Our Ref: K-2578-IRR-001
Your Ref: OP3043/2019
Date: 31 May 2019

Re: Information Request – Operational Works – 12 Crawford Street, Mossman

Response

JOB No: **K-2578**
SHEET: **C16 | B**
SCALE: AS SHOWN (@ A1)

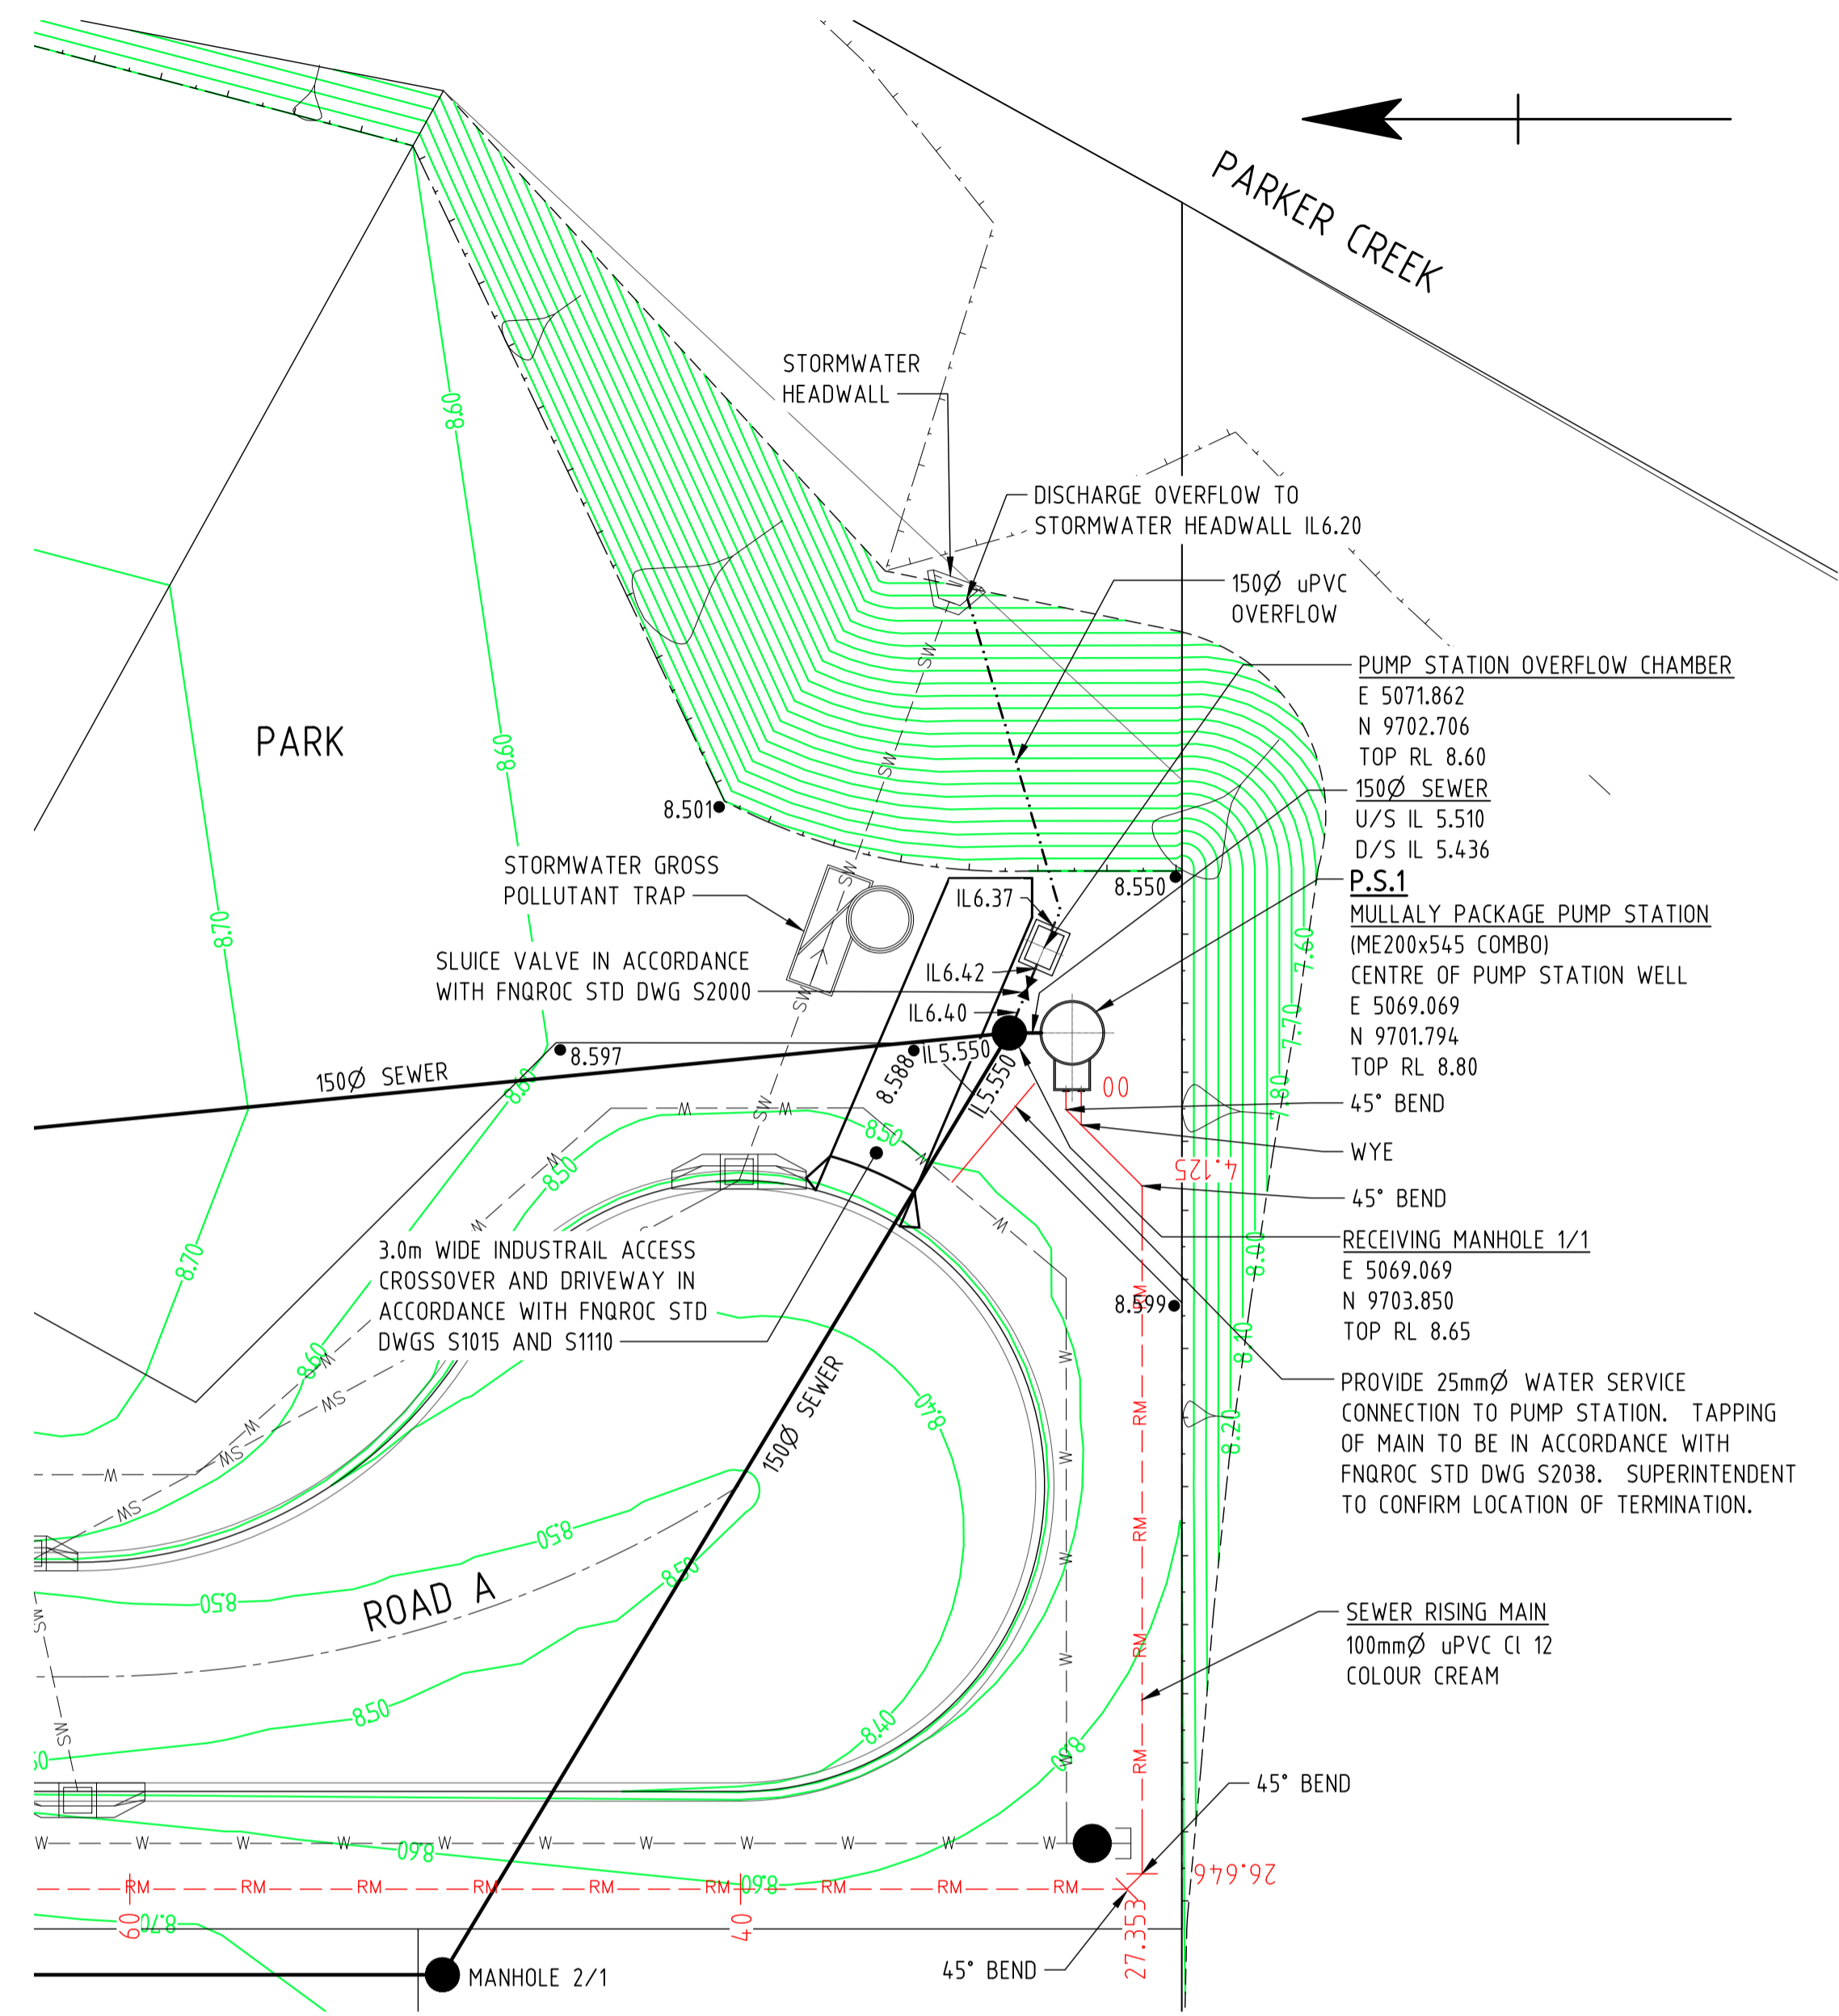
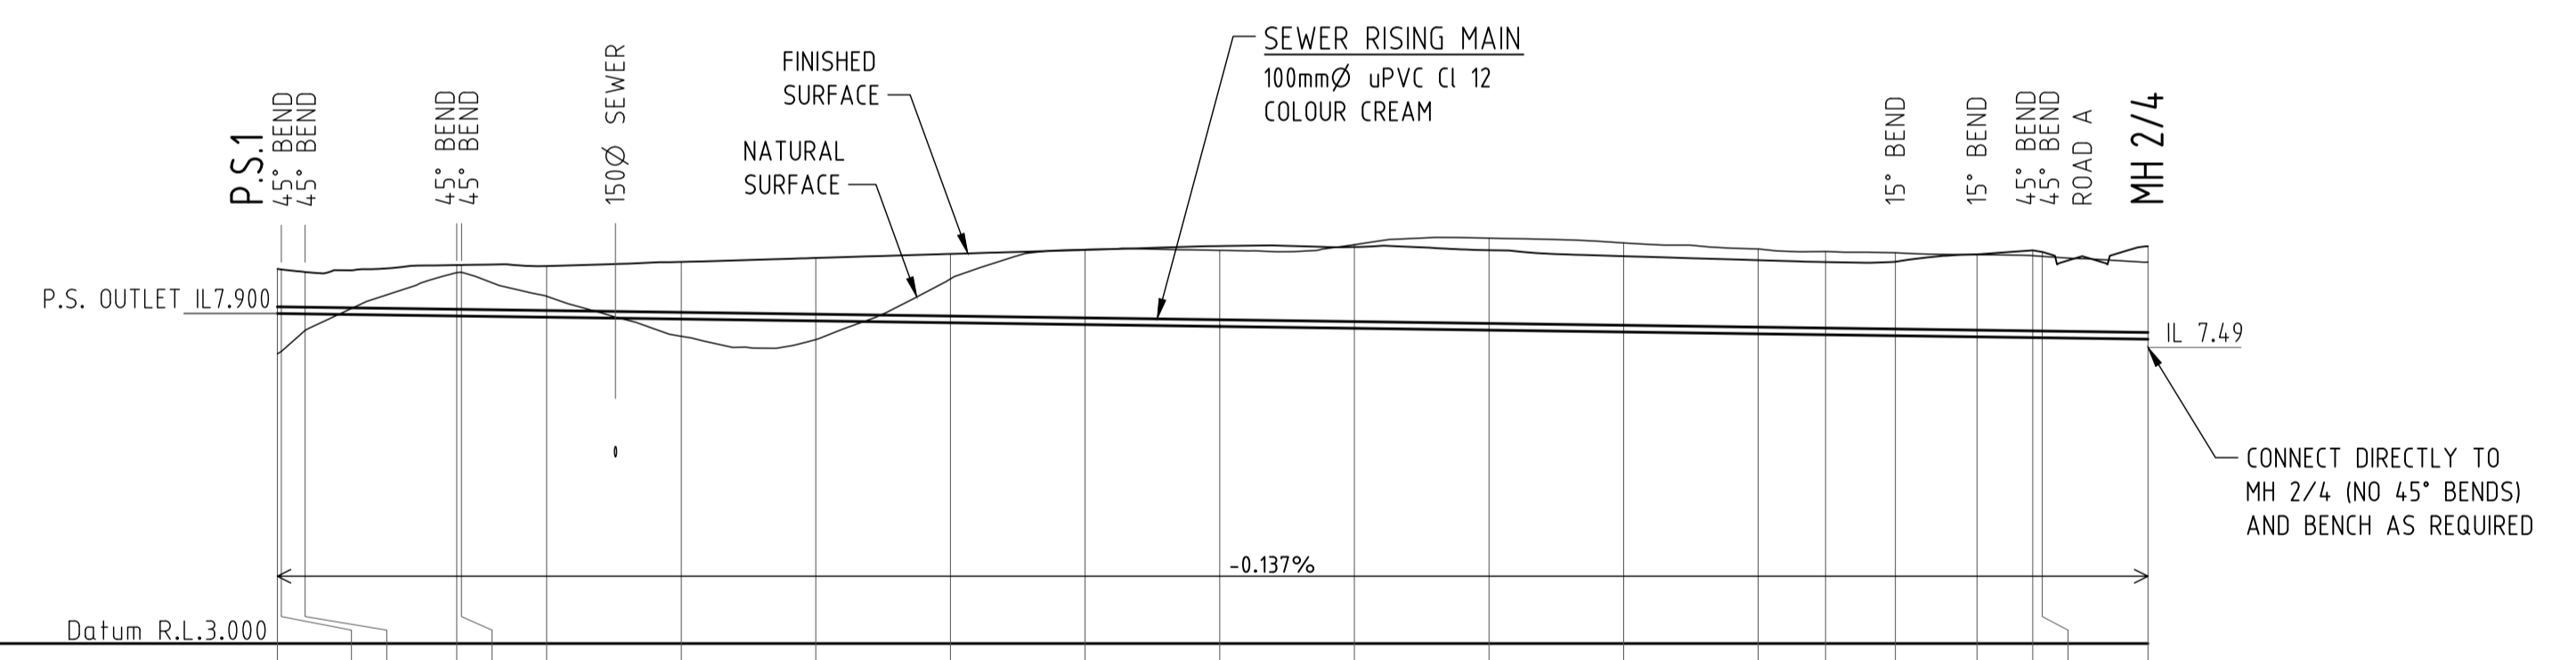
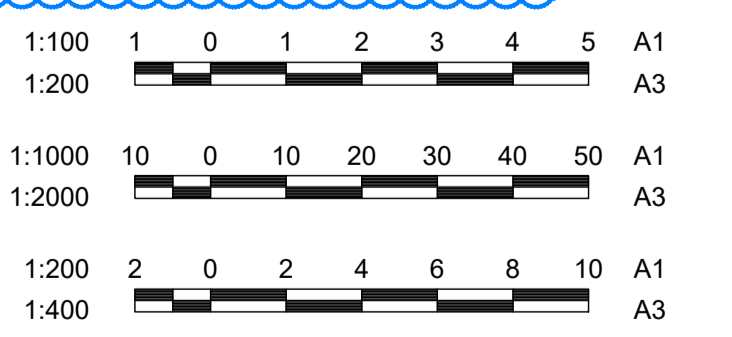
- 19. A concrete access and hardstand area adjacent to the Gross Pollutant Trap (GPT) must be provided to allow maintenance vehicles to park near the roadway in accordance with FNQROC D5.08. Amend the road works drawing to show the proposed access and hard stand extent.**

- 33. The Engineering Drawings provided for the pump station do not comply with FNQROC D7.17. With reference to D7.17 please provide a specific design drawing which includes:**

- 34. The current drawings do not provide suitable access arrangements to the pump station for maintenance. Please amend the drawings to provide hard stand access adjacent to the wet well opening.**

- 37. Provide additional information on the pump station overflow (ie. Overflow chamber invert level, pipe diameter, Parker Creek flooding backflow prevention method etc.).**

- 39. Provide a longitudinal section of the rising main showing proposed invert levels, air valve and scour valve locations etc. The longitudinal section should include the proposed connection elevation to the existing Manhole in Crawford Street and detail how the new connection related to the existing stubs and the proposed new sewer connection. The current application does not provided sufficient detail on the various pipe inlets.**

A 3.0m wide industrial access crossover and driveway has been detailed on Sheet C16 (new drawing) to provide access to both the Gross Pollutant Trap (GPT) and Sewer Pump Station.

Subsequent to obtaining tenders for the subdivisional work a decision has been made to purchase and install a MULLALY MODEL ME200x545 package pump station complete with pumps, controls . Our advice is that a Mullaly package pump station is operating in the Shire. Sheet C16 details the Sewer Pump Station layout.

Drawing C16 details the layout of the Sewage Pump Station and GPT and the provision of a shared concrete driveway.

Drawing C16 details the overflow system and design levels which is based on FNQROC Std Dwg S30035.

Drawing C16 details a longitudinal section of the rising main and its connection to sewer MH 2/4.
